MEMORANDUM

SUBJECT: BZA Case 18527, 1116 K Street NE - request for special exception relief from building lot control (§ 2516.1) and area variance relief from nonconforming structures devoted to conforming uses (§ 2001.3), required rear yard (§ 404.1), and off-street parking (§ 2101.1) to permit two principal buildings on a single lot.

CASE NO. 18527

Figure 1: Subject Lot Showing Structure A and Structure B

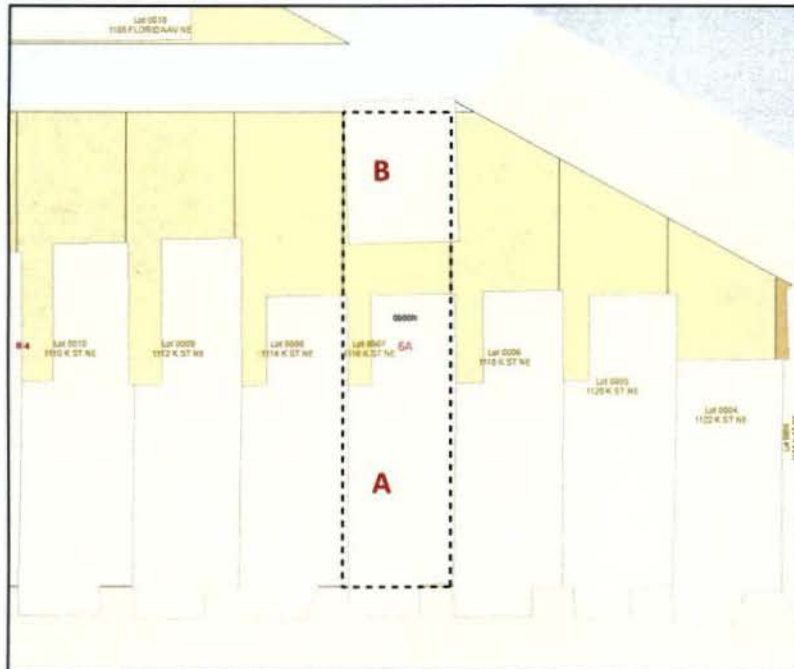
With respect to the expansion of a nonconforming structure (§ 2001.3), the applicant has not demonstrated the exceptional narrowness, shallowness, shape, topography or other extraordinary or exceptional situation or condition that justifies the need to construct the third floor addition. OP recognizes that the rear structure was constructed prior to zoning, served as a commercial business, was placed in the C-2-A zone, and then subsequently rezoned to R-4. However, the existing two-story structure with basement could be re-purposed as a second principal dwelling unit without the need for the third floor addition.

OP cannot support the request for relief from § 2001.3 to expand the existing nonconforming structure. With the addition of the proposed third floor, which would bring Structure B to a height of 30 feet and ½ inch, Structure B will no longer be compatible with the other alley dwellings located on the block and will not be in keeping with the surrounding architectural character.

As required by § 2516.3, OP recommends that the Board require the applicant to submit a final landscaping plan prior to approval, and does not recommend relief that would allow the construction of the third floor.
